SUBJECT: Resource Conservation and Recovery Act Facility Investigation/Remedial Investigation Report with Baseline Risk Assessment and Corrective Measures Study/Feasibility Study for the Early Construction and Operational Disposal Site L-3 (East of L Area) (NBN), L-Area Rubble Pit (131-1L), and L-Area Rubble Pit (131-4L) Operable Unit (U) (SRNS-RP-2023-01365, Revision 1, January 2025) (Redline Pages) and Savannah River Site's Responses to the Regulatory Comments on the Revision 0 Document, SEMS Numbers: 91

1. SRS Responses to the South Carolina Department of Environmental Services' Comments on the Resource Conservation and Recovery Act Facility Investigation/Remedial Investigation Report with Baseline Risk Assessment and Corrective Measures Study/Feasibility Study for the Early Construction and Operational Disposal Site L-3 (East of L Area) (NBN), L-Area Rubble Pit (131-1L), And L-Area Rubble Pit (131-4L) Operable Unit (U) (SRNS-RP-2023-01365, Revision 0, July 2024) SEMS Numbers: 91

2. SRS Responses to the U.S. Environmental Protection Agency's Comments on the Resource Conservation and Recovery Act Facility Investigation/Remedial Investigation Report with Baseline Risk Assessment

Figure CR-1. Aroclor 1254 Data for Surface Soil Media (0 to 0.3 m [0 to 1 ft]) at the ECODS L-3 Subunit

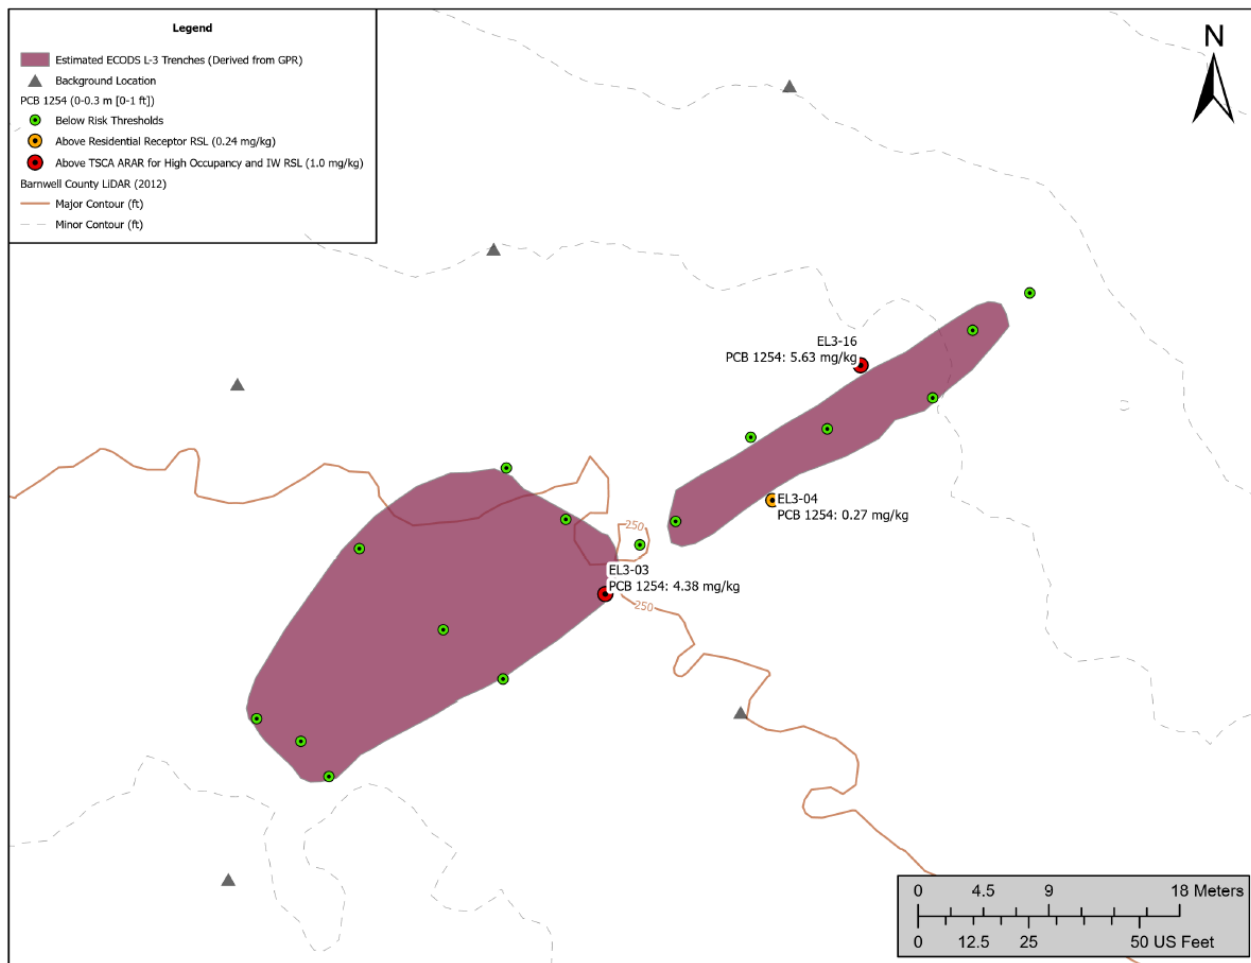
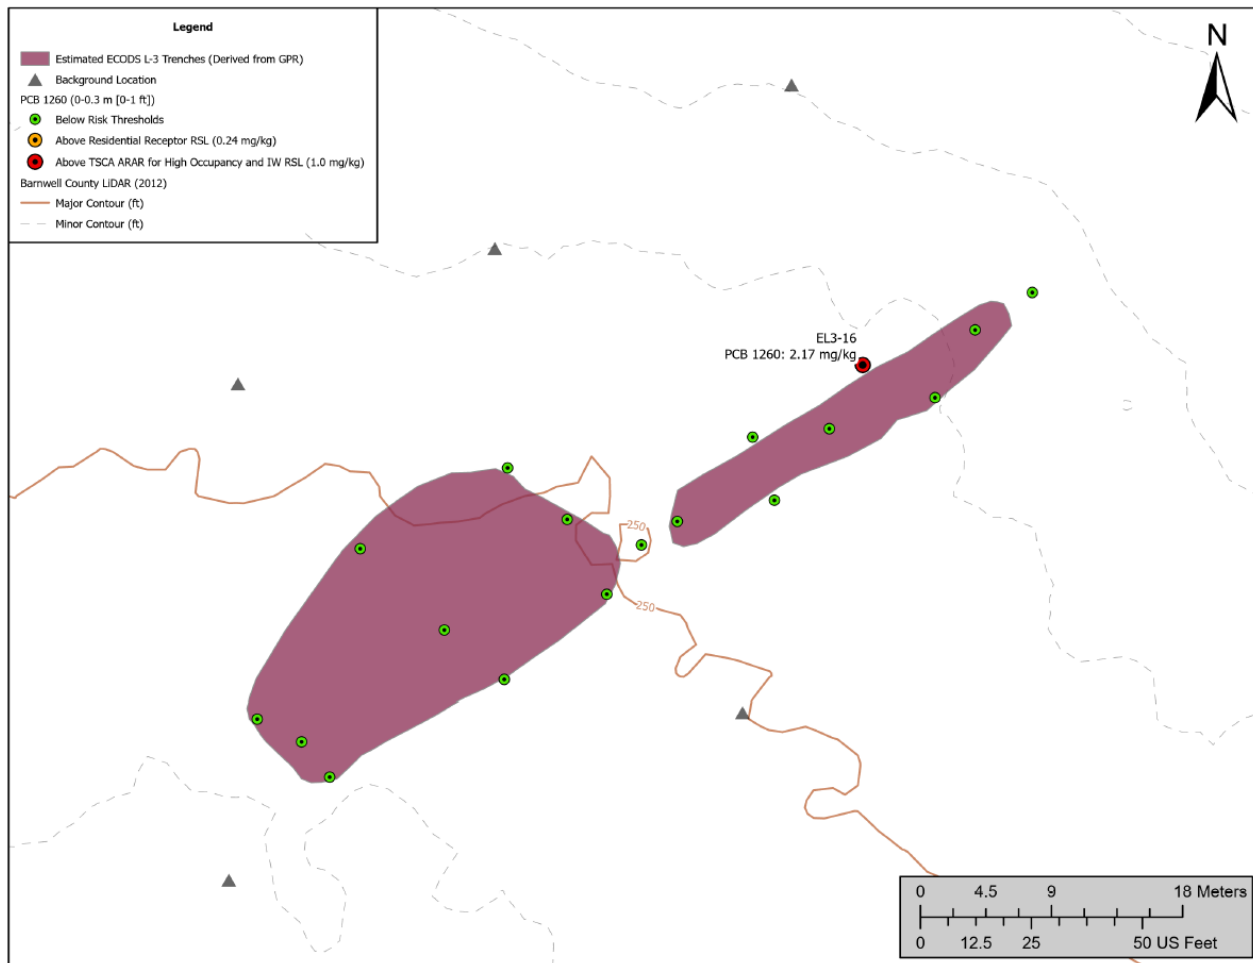
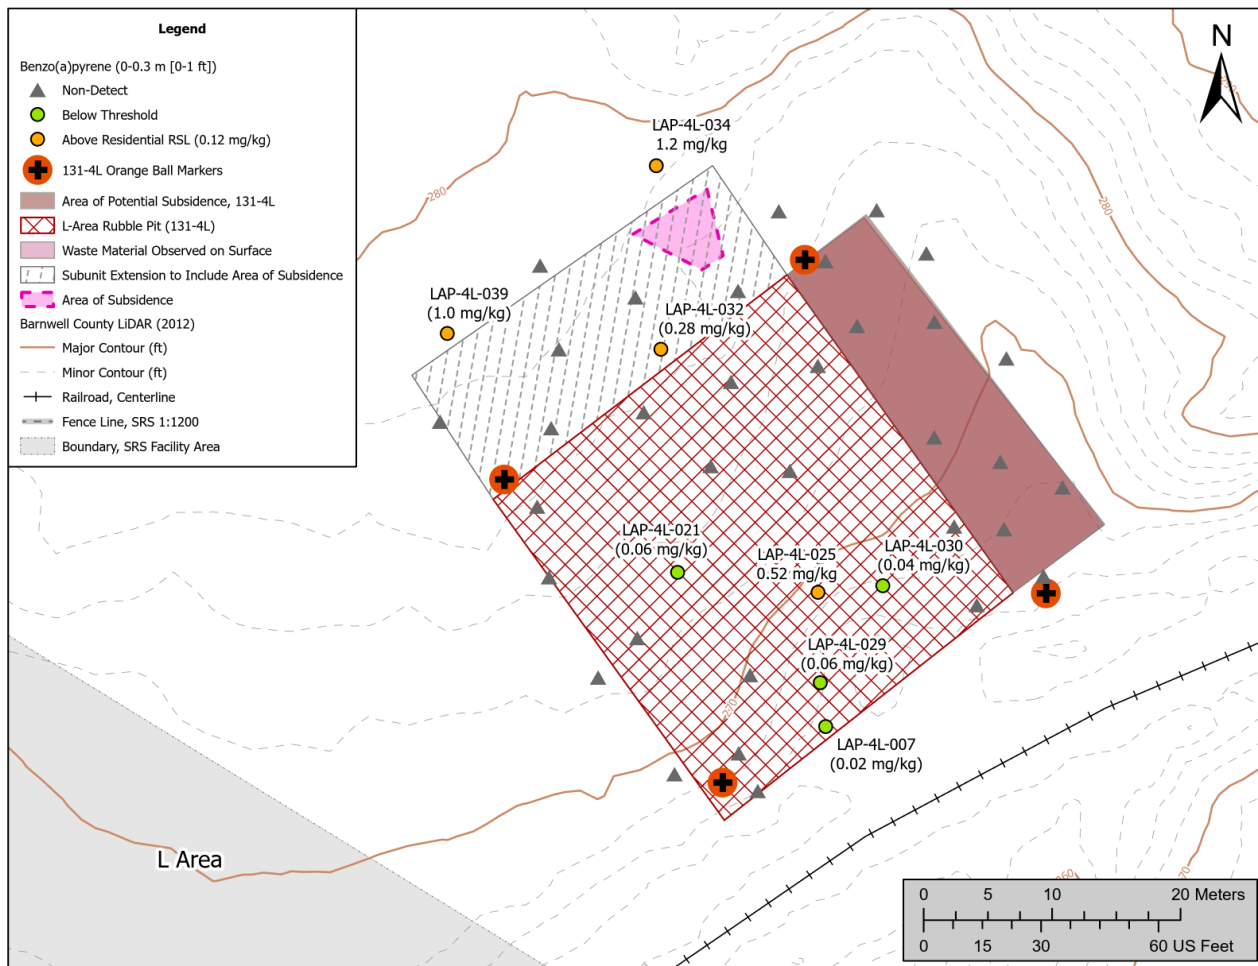
2. The Report does not provide a clear description of the extent of soil contamination at each of the three subunits. For example, Section 3.2.1 (ECODS L-3 Subunit) discusses exceedances of the industrial preliminary remediation goals (PRGs) for several constituents, but the locations and depths of the exceedances are not provided. In addition, the site-specific PRGs are later defined in Section 4.3 (Most Restrictive and Most Likely Preliminary Remediation Goals), so it is unclear what levels were used as industrial PRGs for this comparison. Further, as noted in Section 4.2 (Preliminary Remediation Goal Development) and 4.3 (Most Restrictive and Most Likely Preliminary Remediation Goals) of Format F-5 in the Environmental Compliance and Area Completion Projects Regulatory Document Handbook, dated June 2023 (the EC&ACP Regulatory Document Handbook), the Report should include figures illustrating the locations where the PRGs are exceeded at each subunit. Please revise the Report to provide discussion and figures illustrating the delineation of the extent of soil contamination, including the locations and depths of the PRG exceedances at each subunit.

The SE data was further evaluated in the document appendices to determine the refined constituents of concern (RCOCs) for each subunit. There were no contaminant migration (Appendix B), ecological (Appendix D), or principal threat source material (Appendix E) RCOCs identified for the ECODS L-3, LRP 131-1L, or LRP 131-4L subunits. The human health risk assessment identified Aroclor 1254 and Aroclor 1260 as RCOCs for the ECODS L-3 subunit surface soil (0.0 to 0.3 m [0 to 1 ft]) and benzo(a)pyrene as an RCOC for the LRP 131-4L subunit surface soil (0.0 to 0.3 m [0 to 1 ft]). Risk-based PRGs are identified in Appendix F and presented in Table F-1 for the ECODS L-3 subunit and the LRP 131-4L subunit. Appendix C presents the locations for the RCOCs exceeding PRGs in Figure C-4 through Figure C-6. SRS agrees that Chapter 4 does not include figures described per the EC&ACP Regulatory Document Handbook and the document will be revised as follows along with inclusion of Figure CR-1 through Figure CR-3.

“The HHRA is presented in Appendix C of this document. Aroclor 1254 and Aroclor 1260 were identified as HH RCOCs in surface soil media at the ECODS L-3 subunit for the resident scenario (Figure 4-1 and Figure 4-2). Aroclor 1254 and Aroclor 1260 were detected above residential PRGs at three locations, EL3-03, EL3-04, and EL3-16. Benzo(a)pyrene was identified as a HH RCOC in surface soil at the LRP 131-4L subunit for the resident scenario (Figure 4-3). Benzo(a)pyrene was detected above residential

PRGs at four locations, LAP-4L-025, LAP-4L-032, LAP-4L-034, and LAP-4L-039. The range of HH PRGs (risk = 1E-04 to 1E-06, HQ = 0.1 to 3) for the RCOCs at the ECODS L-3 and LRP 131-4L subunits are provided in Appendix F.”

“The most restrictive of the range of HH PRGs is presented in Appendix F and is shown in Table 4-1 and Figure 4-1 through Figure 4-3 for the resident scenario only (i.e., no RCOCs were identified for the industrial worker scenario).”

Figure CR-4. Revised Figure of L-Area Rubble Pit 131-1L Subunit Boundary

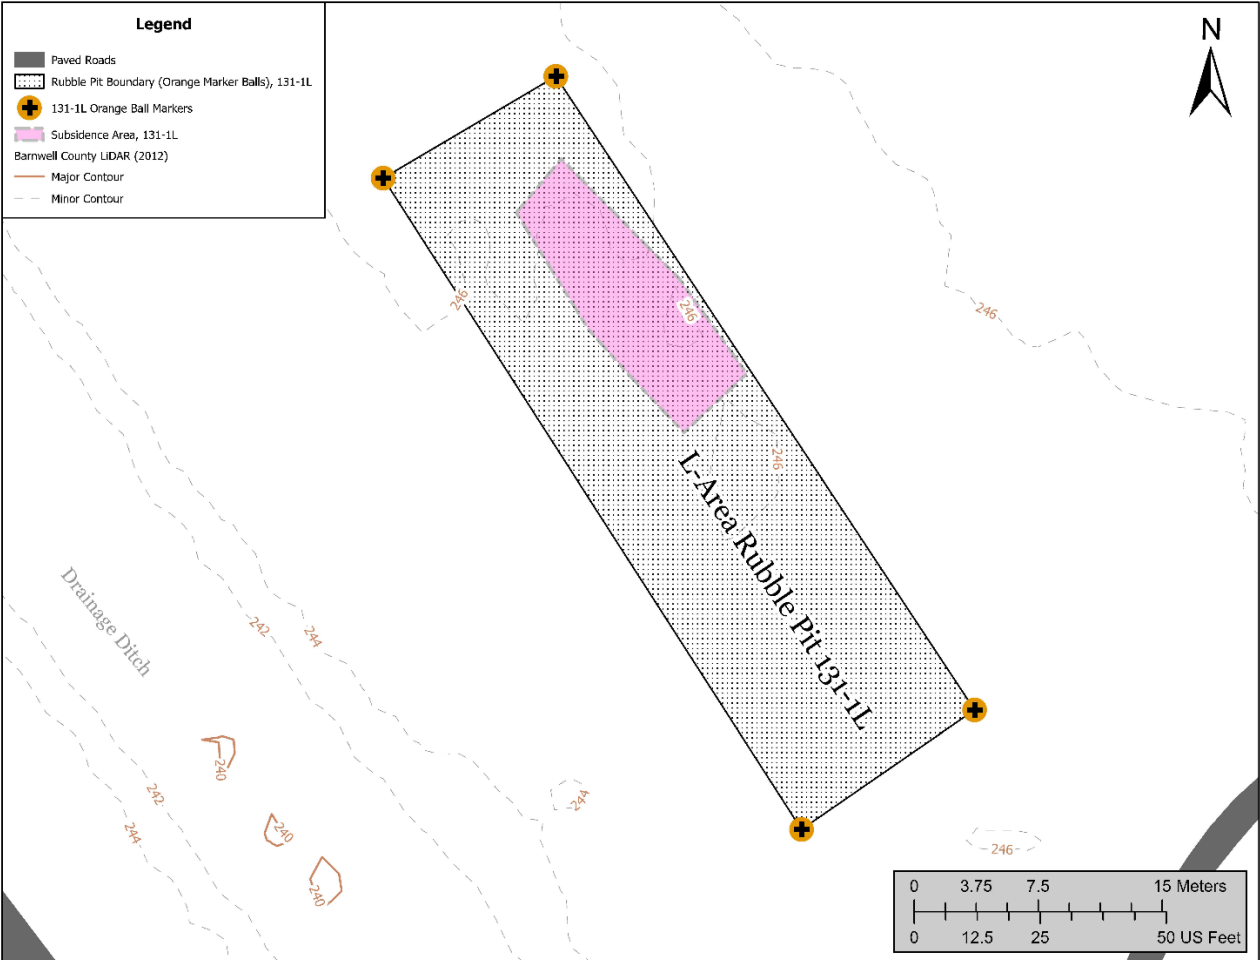
2. **Section 2.1.2, Surface Features, Page 2-3 of 2-34:** The second paragraph identifies a depression approximately 3-feet deep that was observed within the northern end of subunit LRP 131-1L; however, the areal extent of this depression is not discussed, and the depressed area is not shown on Figure 1-3 (L-Area Rubble Pit 131-1L Subunit Boundary). In addition, Figure 2-7 (Depressed Area within LRP 131-1L Subunit) appears to show that the area has standing water, but this is not discussed in the text. *Please revise Section 2.1.2 to discuss the areal extent of the depression and the nature of the surface water and include this feature on Figure 1-3.*

There is a depression that exists within the LRP 131-1L subunit, shown by the photograph in Figure 2-7. The small amount of standing water in the photograph was from heavy rainfall that occurred shortly before the photograph was taken. This depressed area drains quickly and does not regularly hold water. The aerial extent of the

depressed area is approximately 92 square meters (110 square yards). The feature will be included on the figure as shown in Figure CR-4 and the document text will be revised as follows.

“The LRP 131-1L subunit is a relatively flat area that slopes gently to the southwest towards an open drainage ditch with surface elevation ranging from 74 to 75 m (244 to 246 ft) amsl (Figure 1 3). The drainage system discharges to L Lake, ~830 m (2,700 ft) away. A depression, ~1 m (3 ft) in depth and 92 square meters (m²) (110 square yards [yd²]) in aerial extent, was observed within the northern end of the subunit (Figure 2-7). The depression receives rainwater runoff, however the soil drains well and does not regularly hold water. The subunit is marked by four orange balls marking the corners of the subunit and established signage (Figure 2-3).”
